**NOVEMBER 16, 2010 ZONING HEARING
“OTHER BUSINESS”
COMMISSION DISTRICT 3**

ITEM # 3

To consider a site plan and stipulation amendment for Ashley Ocampo regarding application OSC-03-01 (Travis Pruitt & Associates) of 2003, for property located on the south side of Blackwell Park Drive, east of Johnson Ferry Road in Land Lot 688 of the 16th District.

Site for Other Business 3

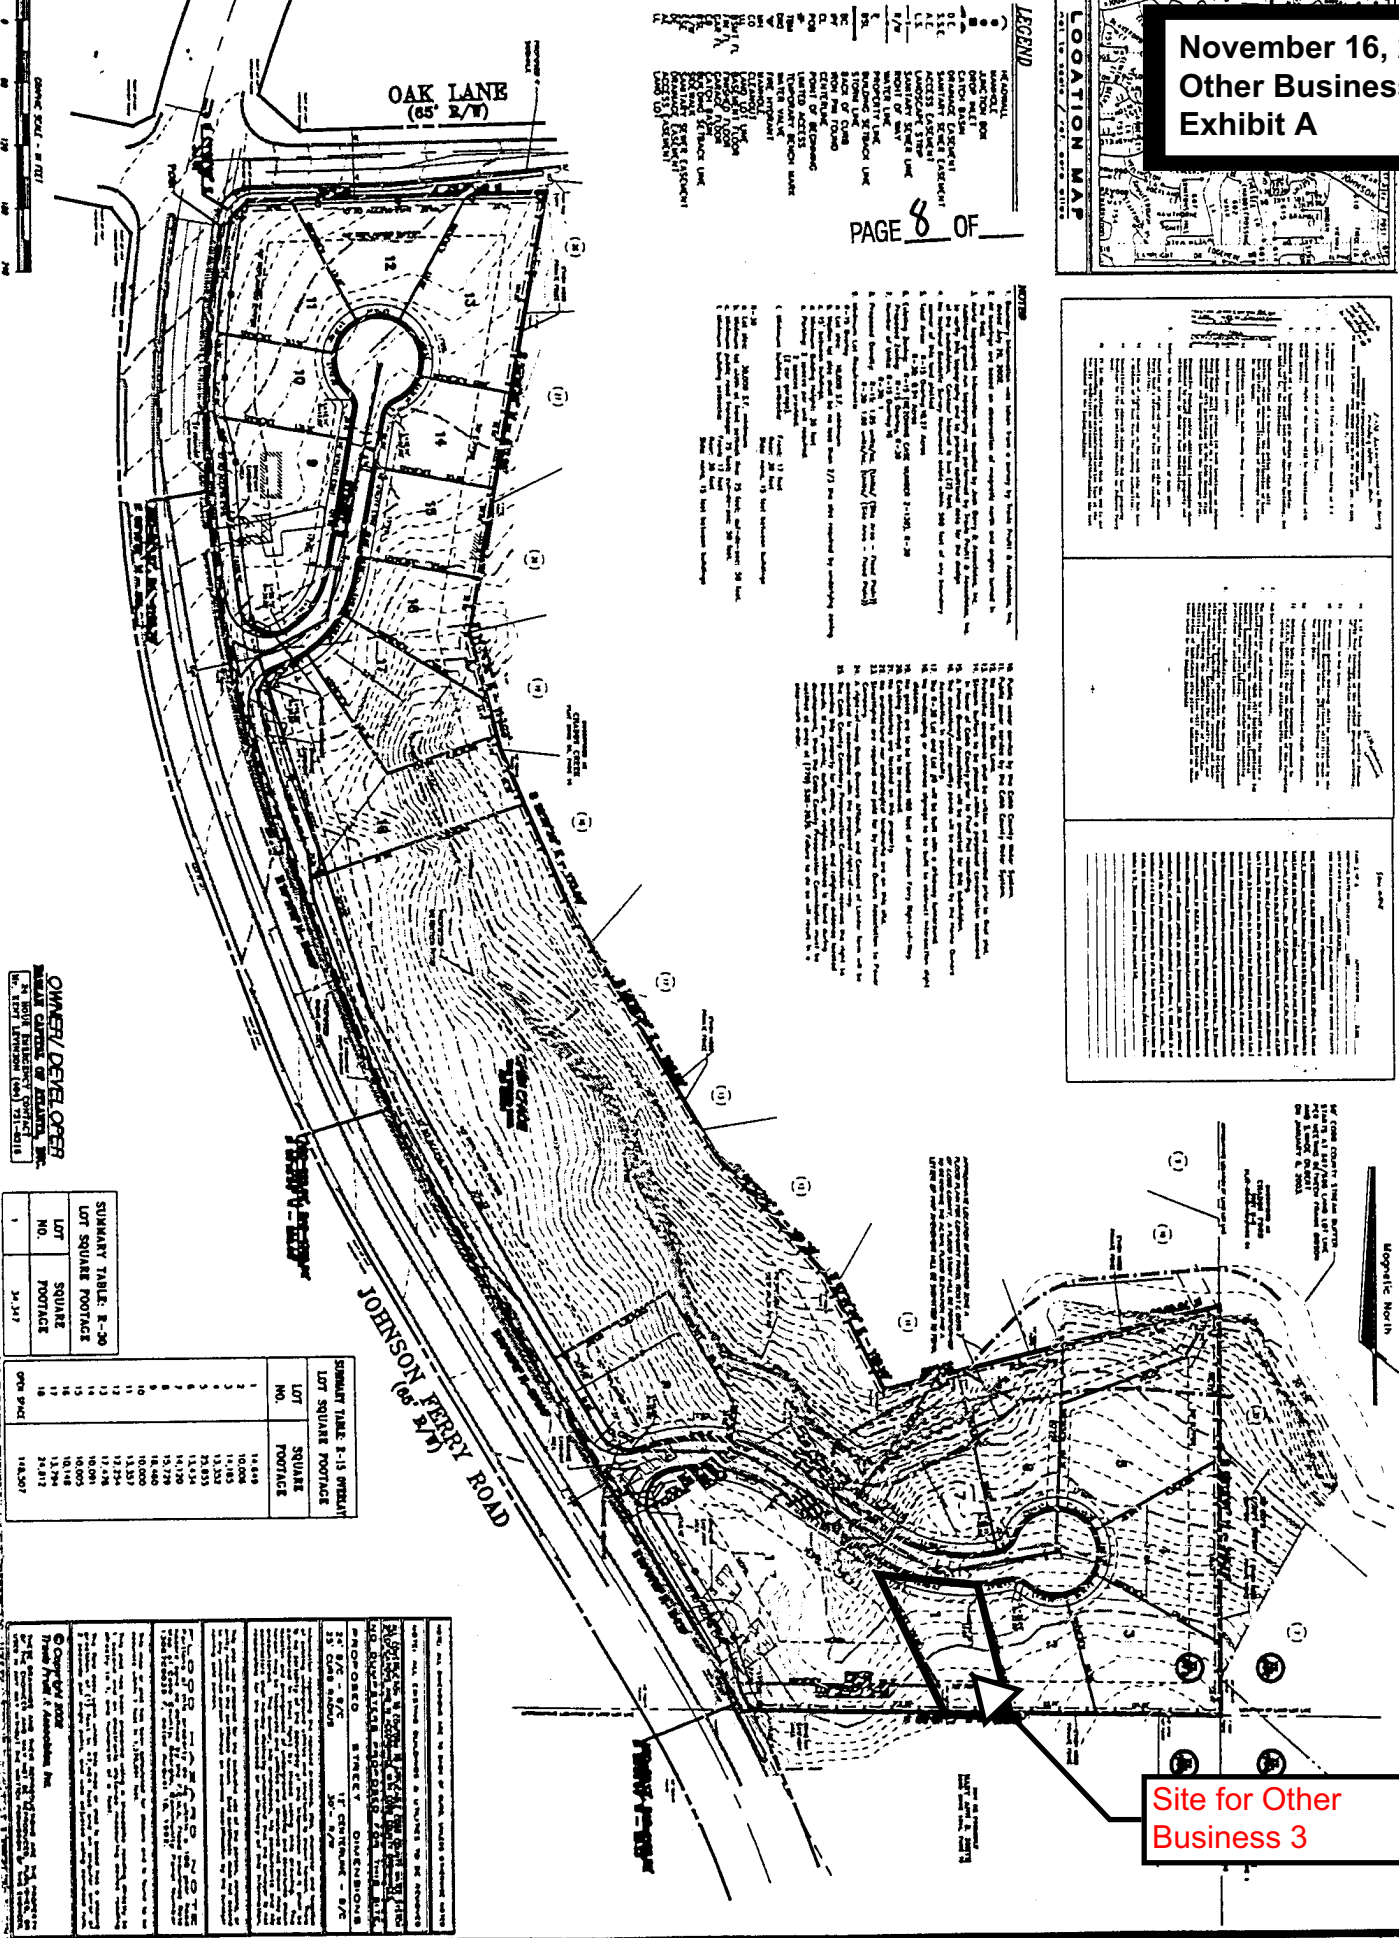
The proposed zoning (R-30 OSC Overlay) does not correspond to proposed lot layout. The rezoning case is currently pending.

Detention and water quality requirements must be met. The proposed detention ponds must be placed on separate lots or provisions for an HOA must be stipulated with a mechanism to maintain the facilities in perpetuity.

A portion of the site lies in a FEMA Zone A floodplain. A Letter of Map Amendment will be required to establish detailed flood elevations.

The Georgia Stormwater Management Manual and soon to be adopted Model Stormwater Ordinances require that for open space and conservation subdivisions portions of the site with slopes greater than 25% should be included as part of the open space/conservation area.

Site plans will be required for all lots adjacent to the stream buffer or located on slopes greater than 15%.

Recommend no reduction or variance allowed on stream buffers where ground slopes exceed 15%. Recommend all houses to be built on lots with ground slopes greater than 15% be located at the front set back with front loading garages. All grading should be limited to the roadway and building pads only.

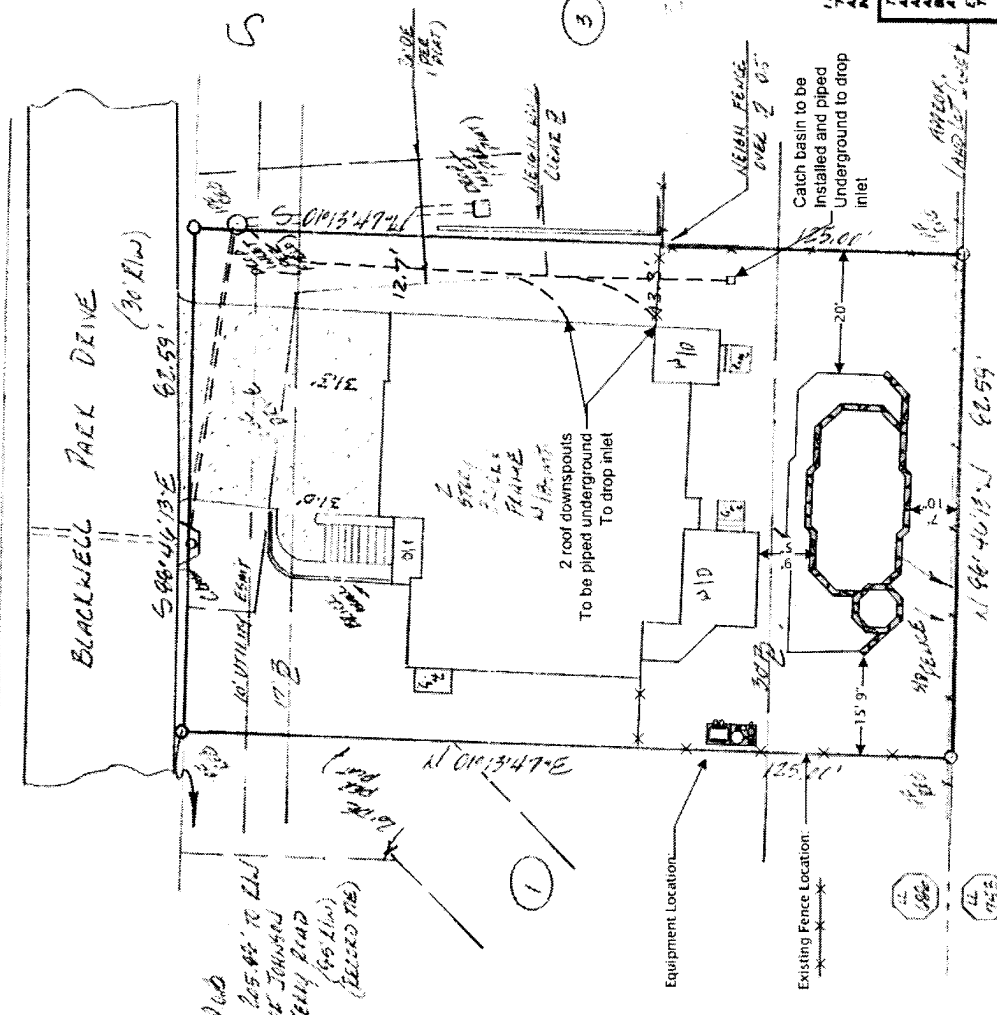
1. Connect all existing downspouts on the Ocampo's side of the property to the drop inlet at the front corner of the property.
2. Install a surface drain in the back yard to catch surface runoff from the pool and back corner of the Ocampo's property.
3. Move the pool to the original proposed location and maintain the pool, deck and associated structures 20' from Mr. sultan's property line.
4. Install an evergreen buffer of Leyland Cypress or similar material between Mr. Sultans property and the pool .
- 5 All pool equipment to be installed on the opposite side of the property from Mr. Sultan's residence as shown on the site plan.

The attached amended site plan shows the revisions requested by Mr. Sultan. In addition the deck was reduced and the equipment is moved to locate if out of the buffer to conform with the request by the commissioner's office after the original submission was returned for revision.
